Dear Samuel,

Thank you for your comments and please see our reply below. Thanks.

SAR value for various output power

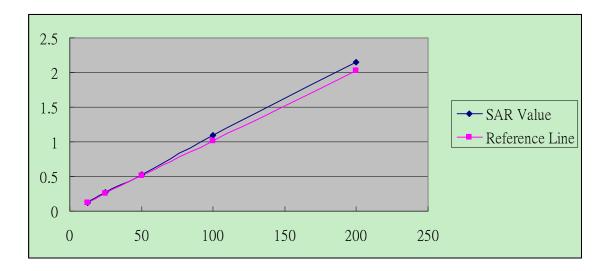
- 4. Please note that the reference lines in the SAR measurement linearity plots are incorrect. Reference line is established using measured points corresponding to probe sensors operating in the square law region; typically with the DUT operating at less than 20mW. The power at less than 20mW is used to establish the slope for the reference line for comparison with other measured SAR values to establish the error margin. Please show how your reference was determined and SAR estimated <TCB reply> Please note that the SAR linearity plots is based on 12.5mW SAR test as we discussed in later Moto application. And calculated as below:

SAR at 12.5mw= 0.127

Expected SAR at 200mw= $0.127 \times (200/12.5) = 2.032$ mw/kg

The measured SAR at 200mw= 2.15mw/kg

The error is (2.15 mw/kg - 2.032 mw/kg)/2.032 mw/kg = 0.05807 = 5.81%

So the calculation in SAR report is correct. I copy related portion below for your convenient. Thanks.

From the above evaluation, it suggests that the SAR result is about 5.81% over estimated. Accordingly we believe that the final SAR result is conservative.
